UNITED STATES  
NUCLEAR REGULATORY COMMISSION  
WASHINGTON, D. C. 20555

Docket No. 50-213  
LS05-80-11-045

PLANT DESIGN CHANGE REQUEST

TITLE	Spent Resin Storage Facility	PA 79-259
-------	------------------------------	-----------

TITLE: Spent Resin Storage Facility

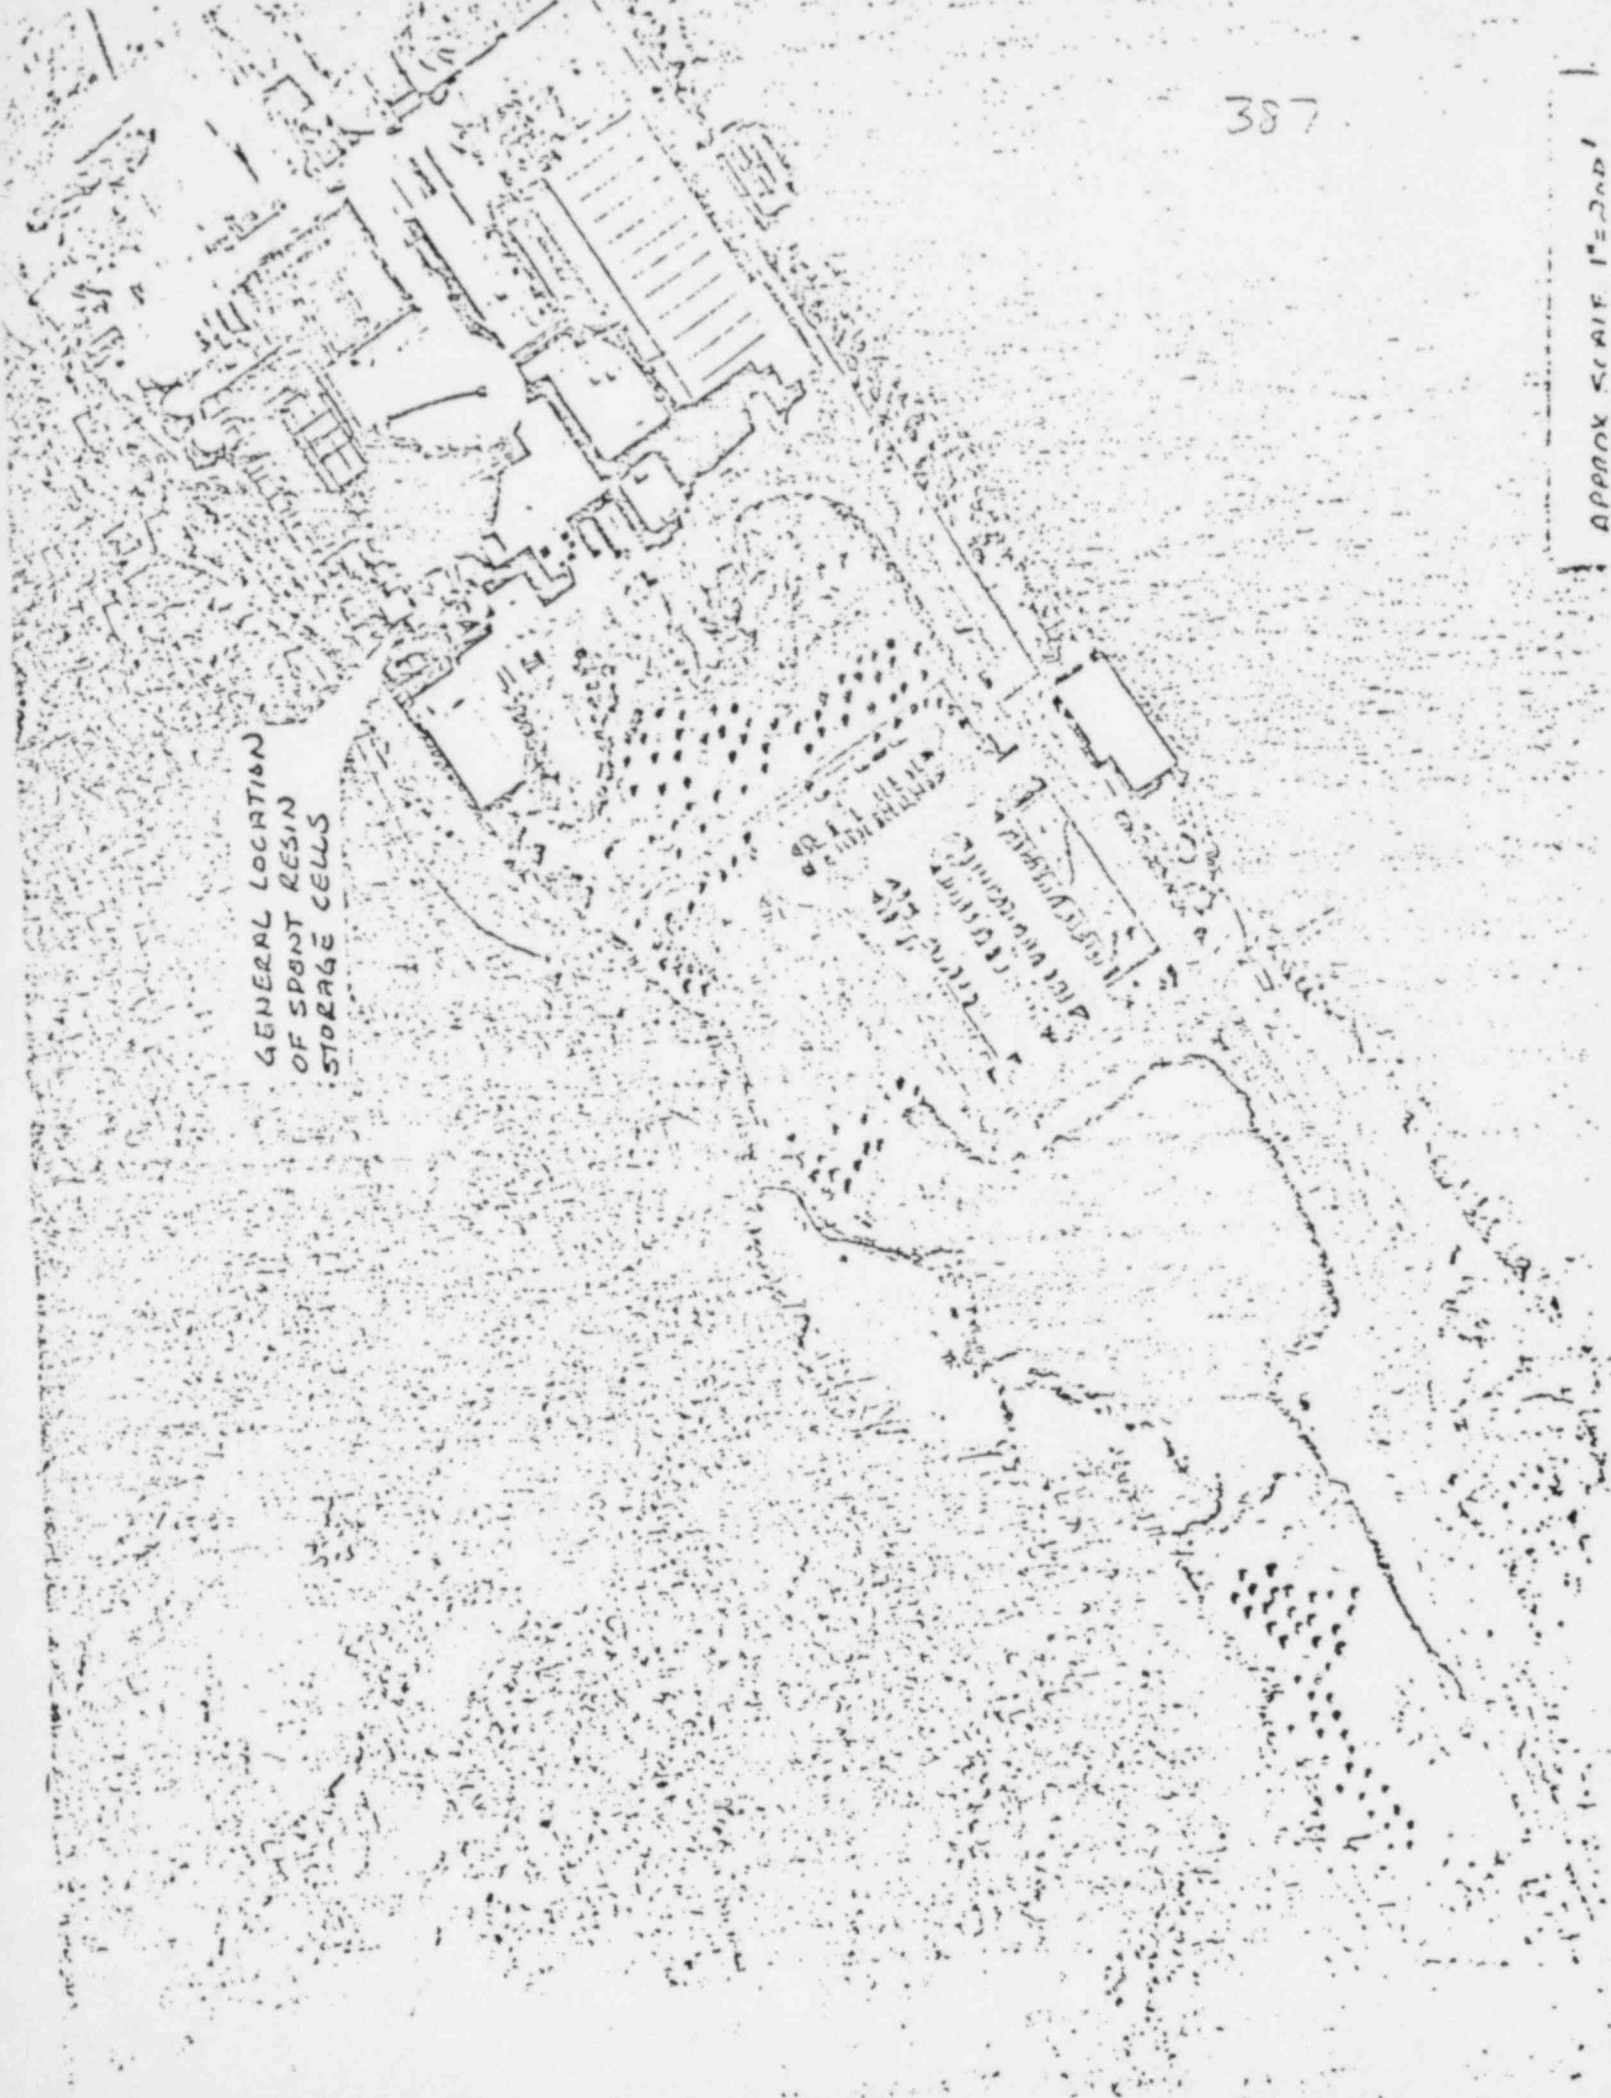
In order to facilitate the transferring job, a bevel should be built on top of each cylindrical cell.

The sketched drawings show the ID of the cylindrical cells as 5'. Since Chem. Nuclear resin liners are 5'1" diameter (OD), the cells ID should be changed to 5'2".

SECTION 1-1

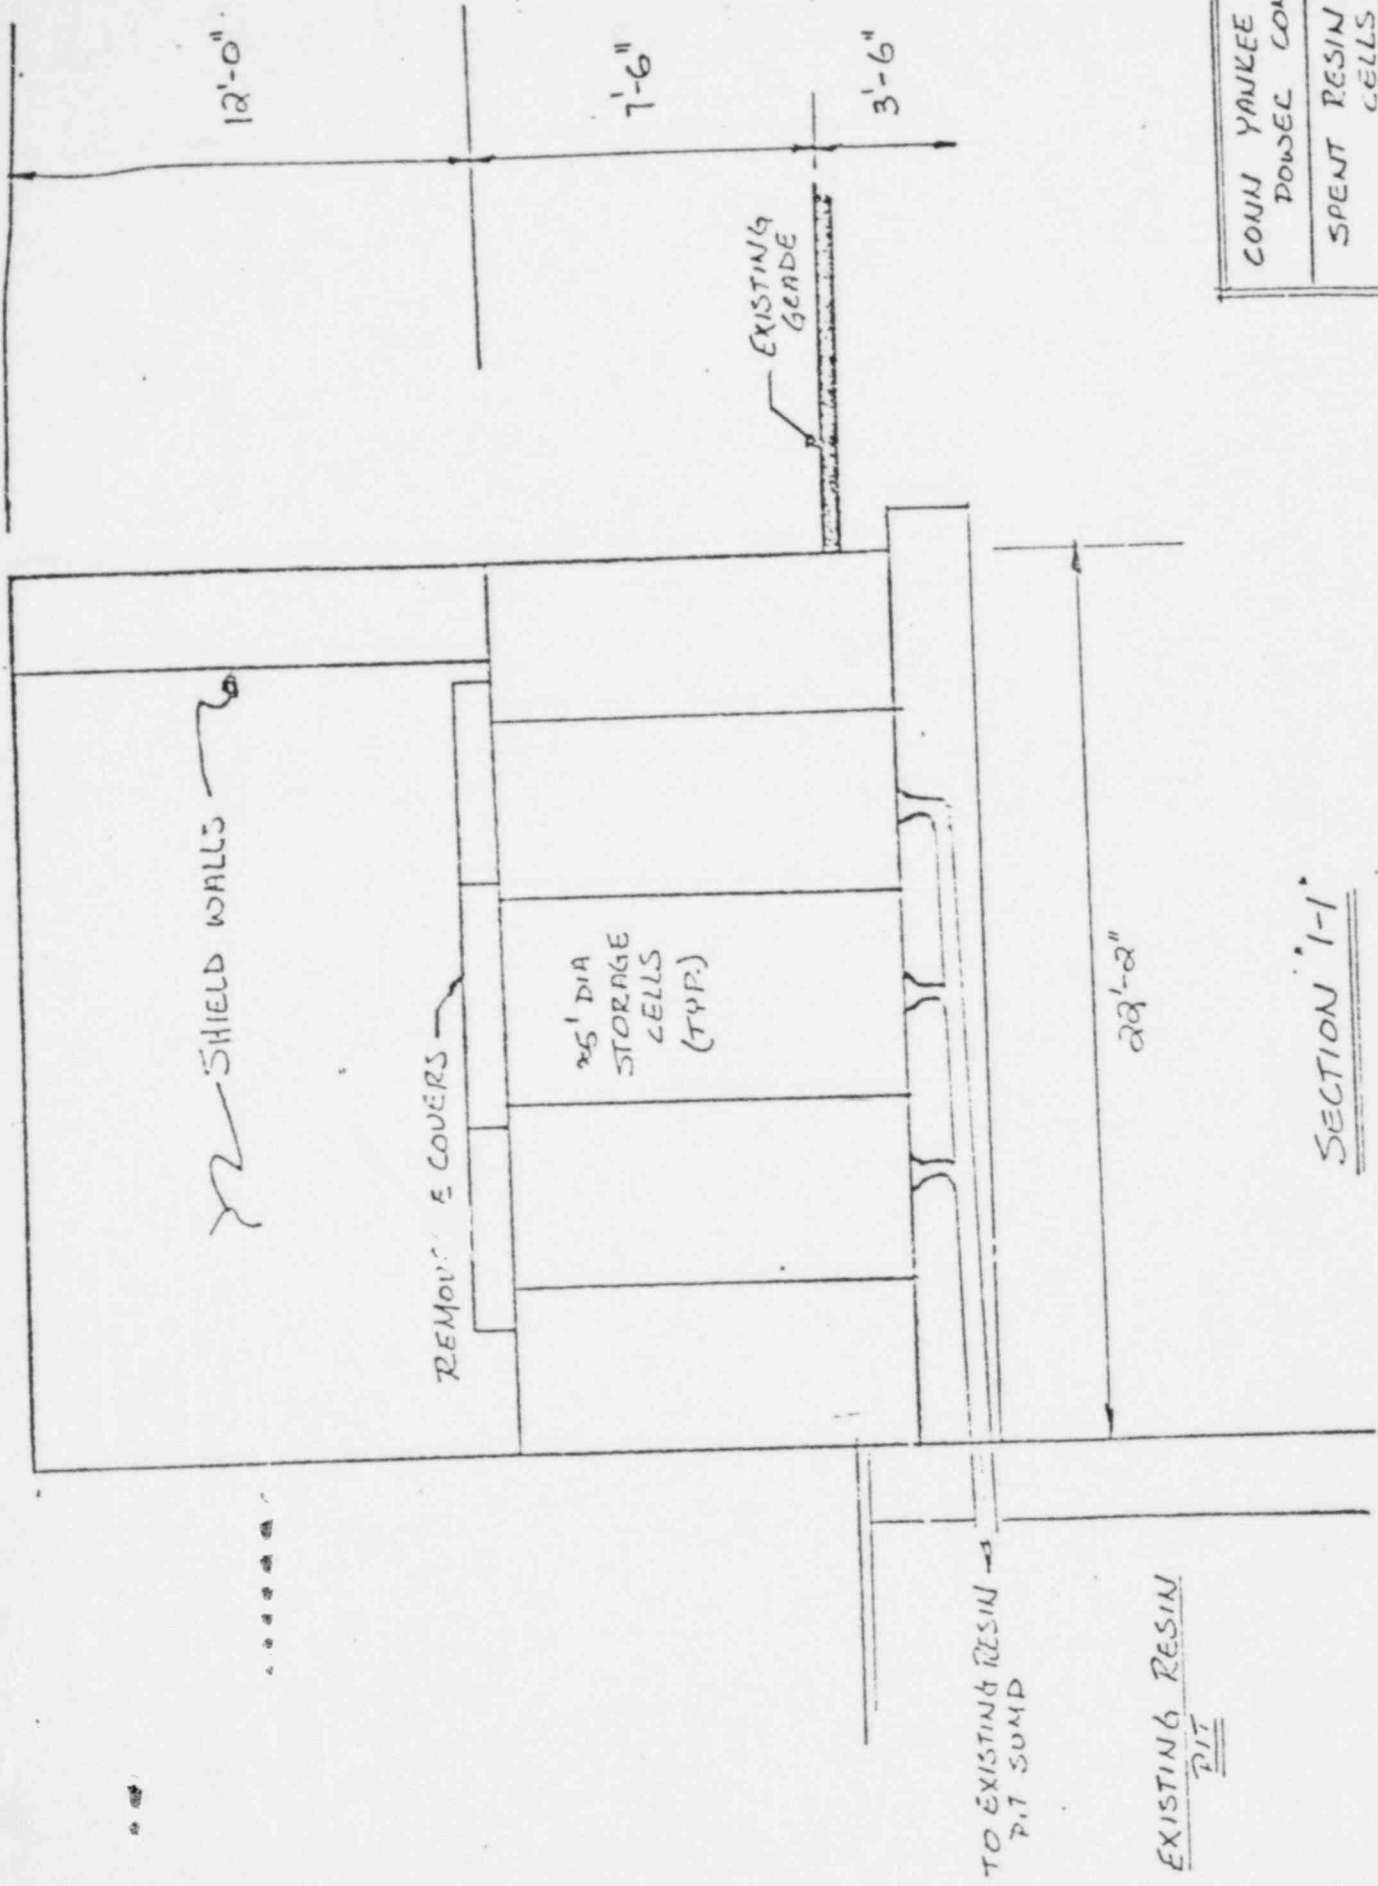
The design of the facility is essentially a reinforced mass concrete block 22' x 29' in plan with a separate cell of approximately 5 feet in diameter for each container. Each cell would be covered with a 2 foot thick reinforced concrete cap seated on a compressible sealing ring. The mass concrete and cap, in addition to providing shielding, protects against any hypothetical missiles. The sealed cap also provides weather protection.

The mass concrete structure founded on rock is not susceptible to earthquake damage. Its design has been checked to verify that even the shield walls which extend to approximate Elevation 41 can withstand the design basis earthquake of 0.17 g zero period acceleration using the spectra shape of Regulatory Guide 1.60.
